CERTIFICATE OF APPROPRIATENESS

RE: Application Number 21-7526; 1321 Labrosse, Corktown Historic District

RE: 1321 Labrosse Street – Application Number 19-6555
Resubmission of previously approved project

RE: 1321 Labrosse Street – Application Number 19-6555

Sheet Number:
A5.10

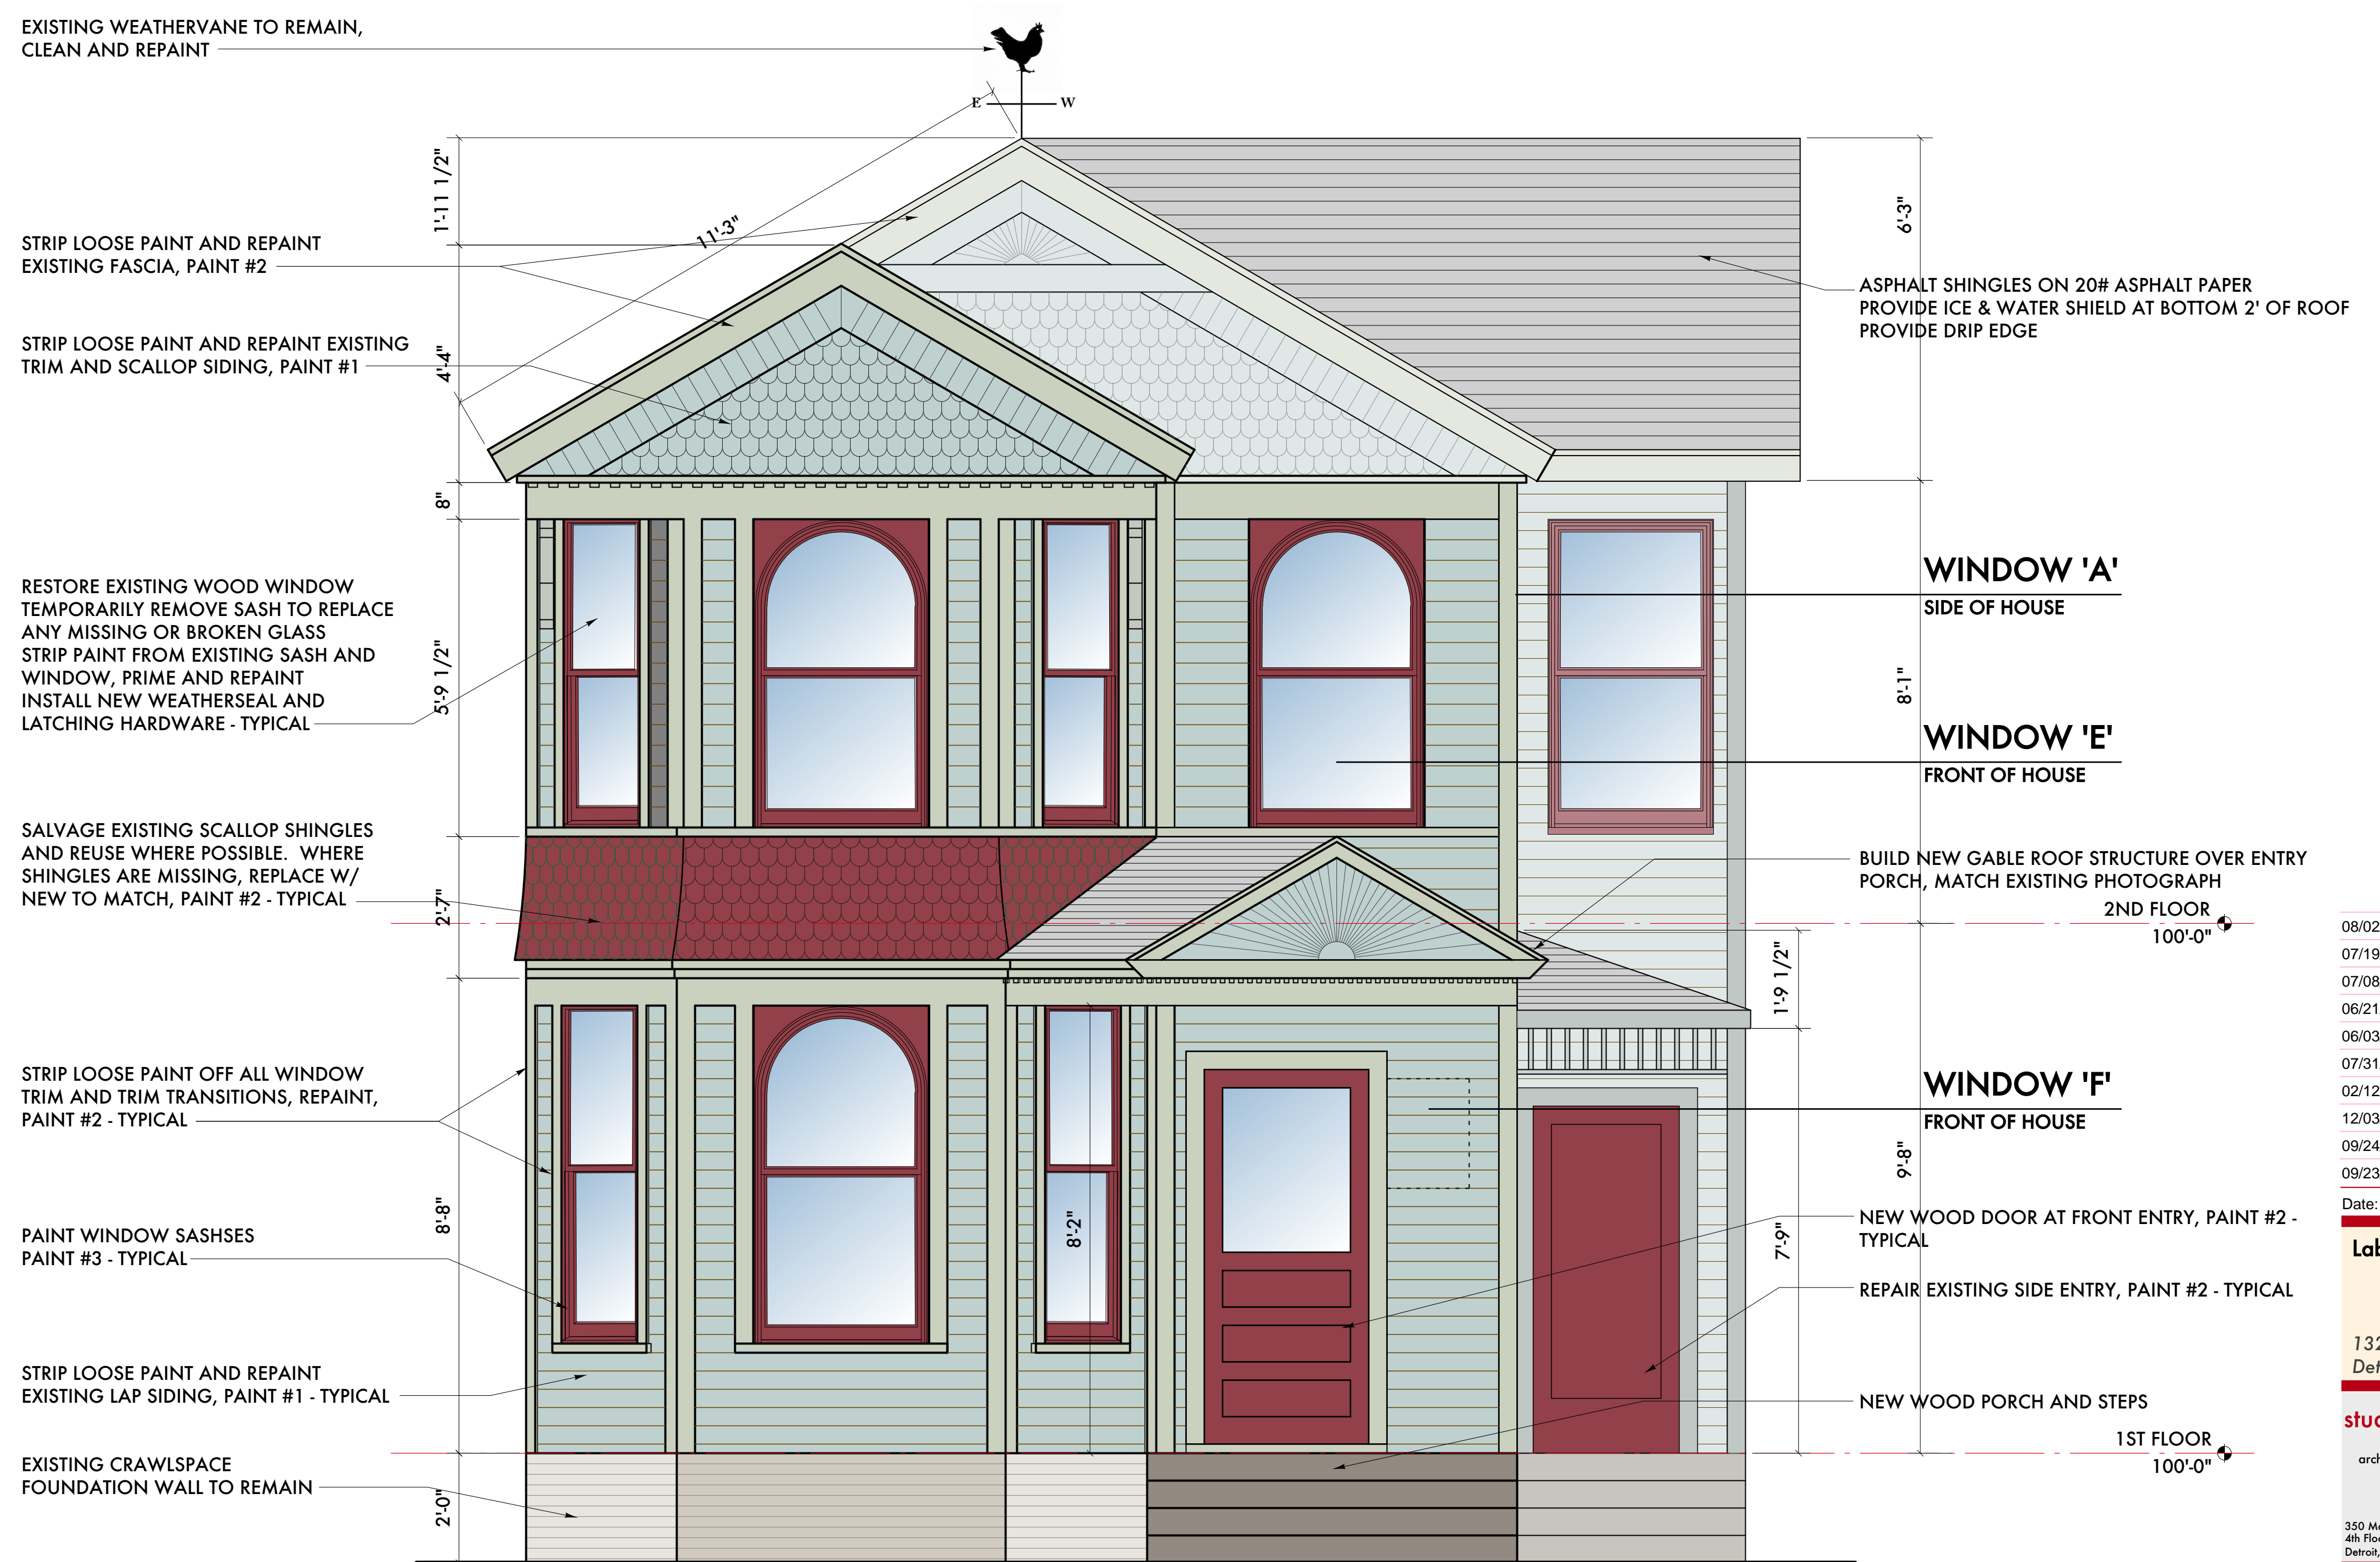
Front Elevation – Second Floor (Window E)

- Reopen previously enclosed and boarded over window opening. A custom one-over-one wood double-hung window will be fabricated to match the existing adjacent double-hung historic windows. Sash will be painted red.

Front Elevation – First Floor (Window F)

- Retain removed and boarded over small window opening adjacent the front door.

West Side Elevation – Second Floor (Window A)

- Remove 1/1 vinyl single-hung window; a 4/4 wood double-hung window will be fabricated from salvaged and repaired historic wood sash (which had been removed from other openings – top sash will have an arch like the historic windows in situ); wood sash to be painted red.

- Drawings confirming the placement, dimensions and construction of the two new custom wood windows (front elevation window will be one-over-one; rear elevation window will be four-over-four with historic muntin dimensions and profile) will be submitted to staff for review.

A5.11

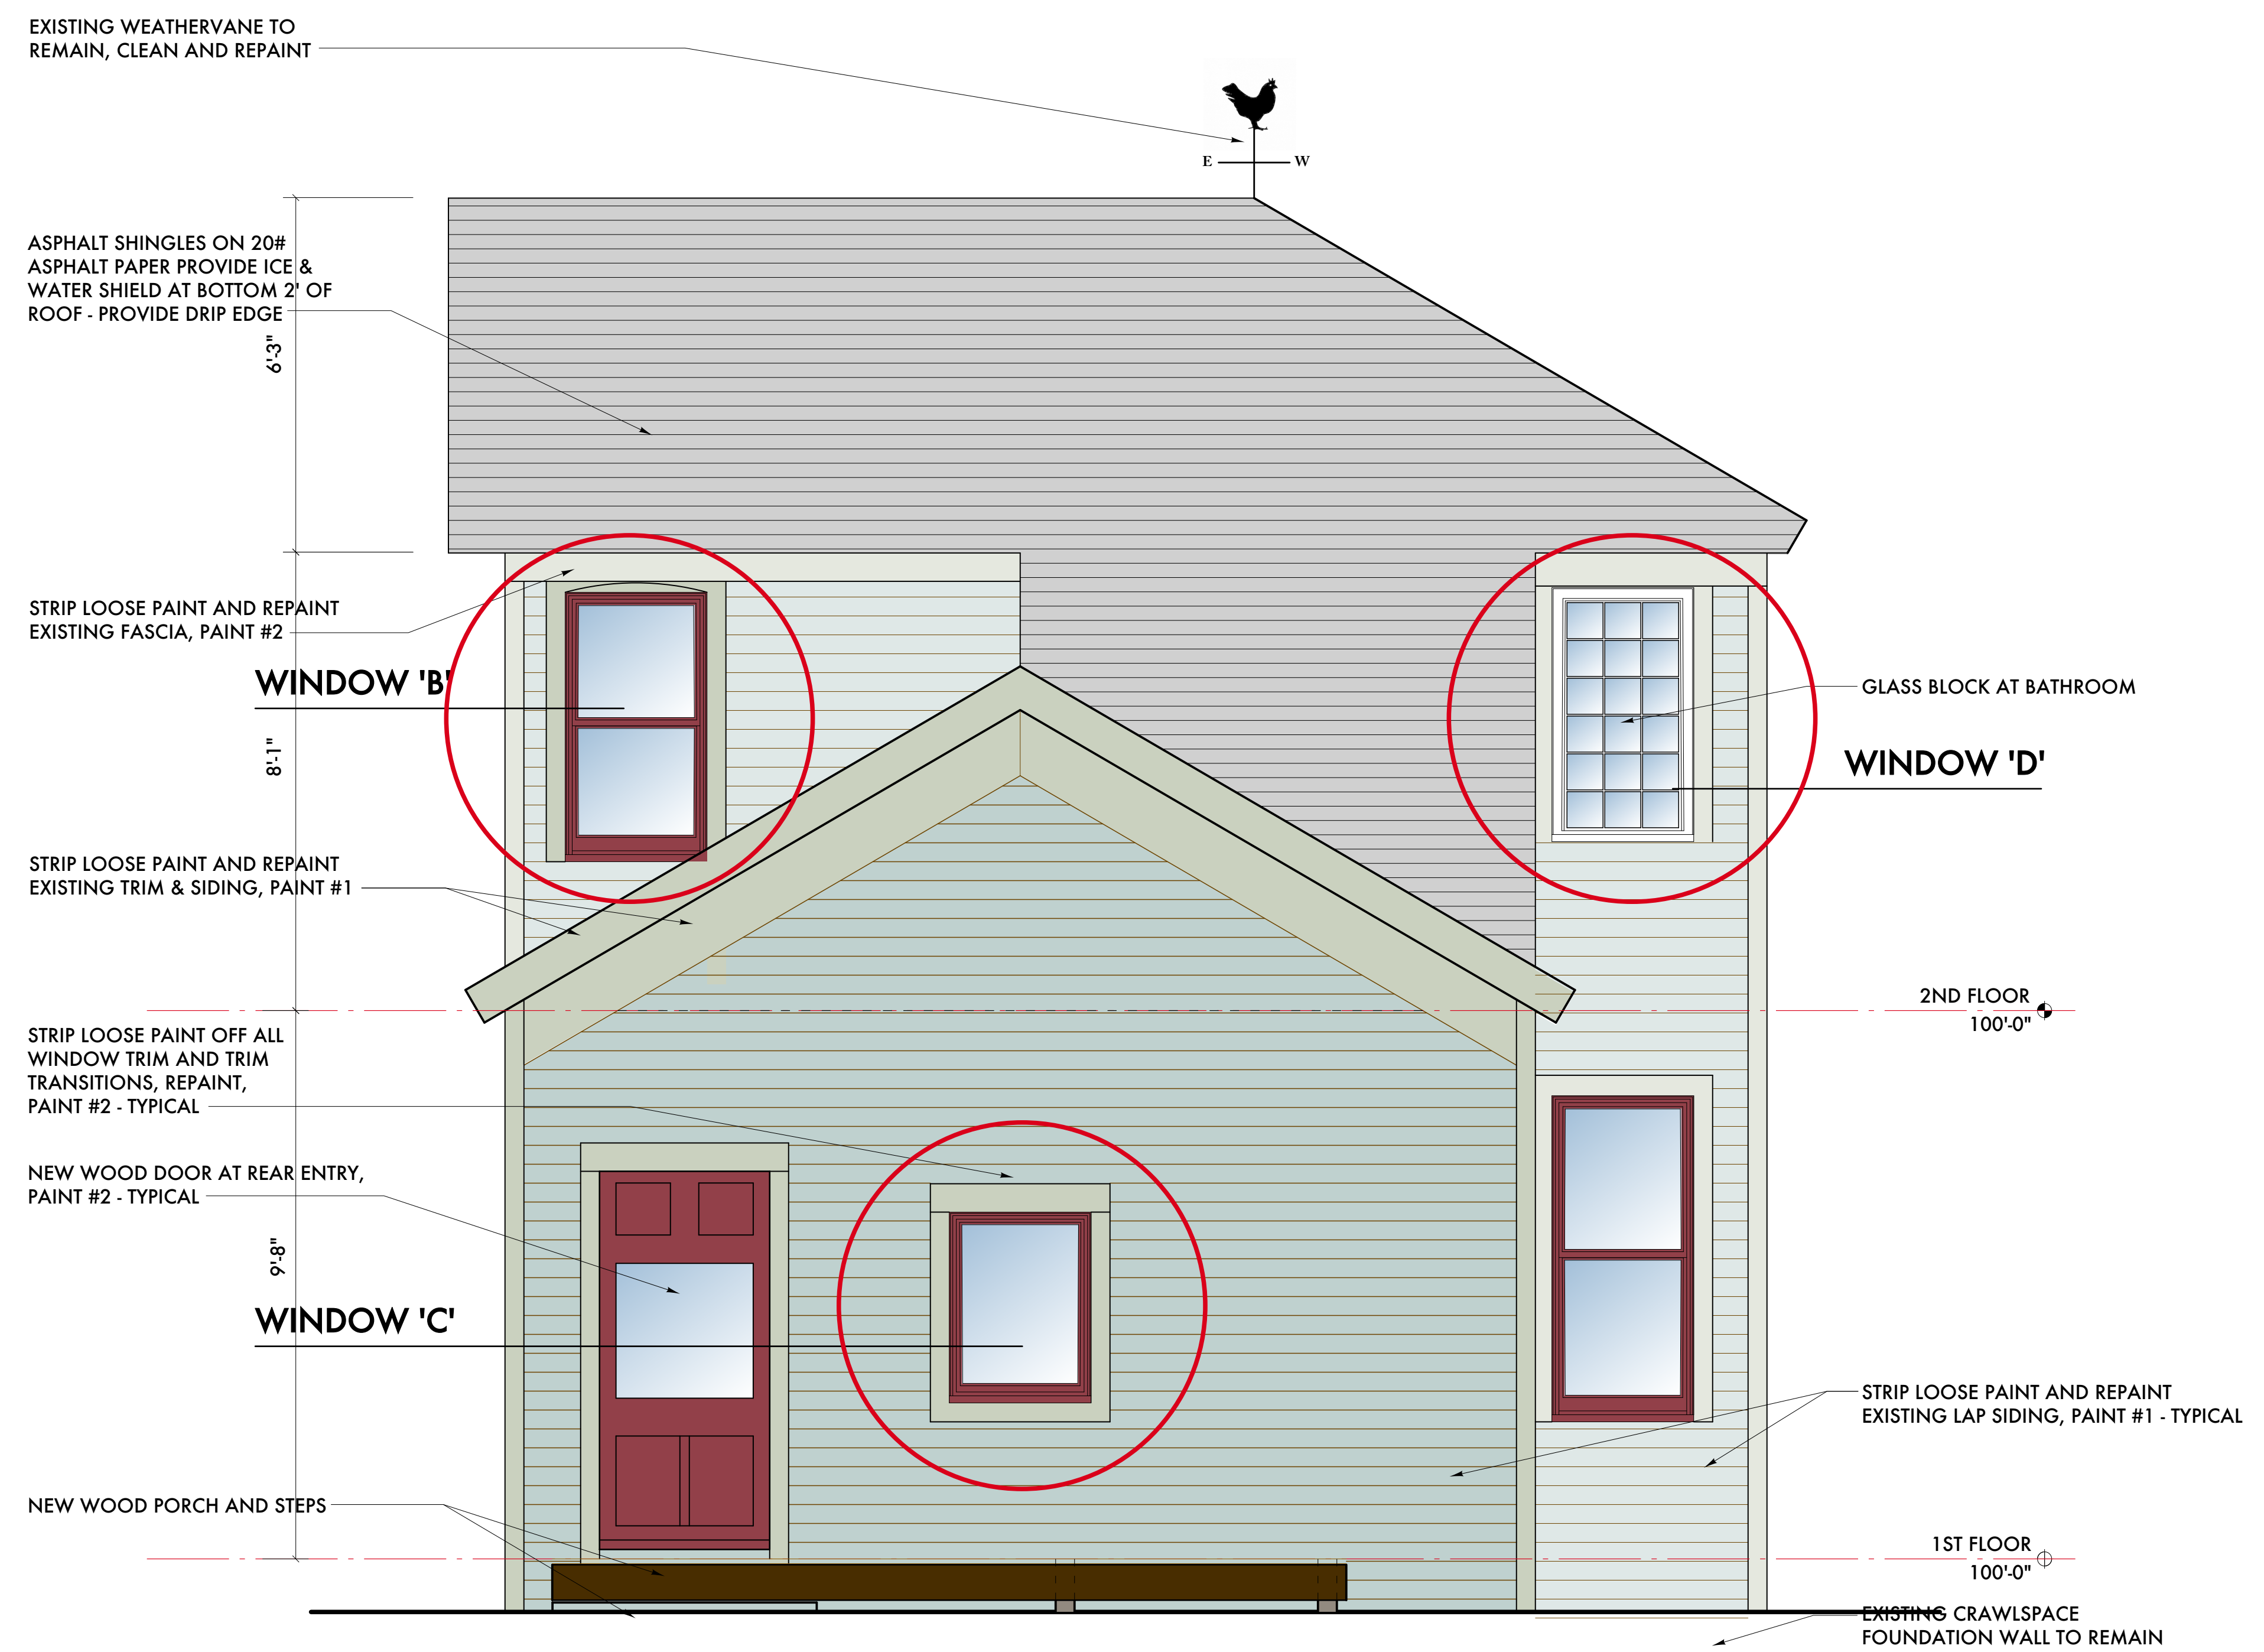
Rear Elevation – Second Floor (Window B)

- Remove 1/1 vinyl single-hung window; a custom one-over-one wood, 4/4 double-hung window will be fabricated to match the historic 4/4 wood double-hung historic windows, sash will be painted red.

Rear Elevation – Second Floor (Window D)

- Removal of one historic, 1/1 wood double-hung window (far right), installation of glass block to remain.

Rear Elevation – First Floor (Window C)

- Removal of one historic, 1/1 wood double-hung window, reduction of opening size, and installation of one vinyl awning window to remain, clear glass, vinyl sash to be painted red.
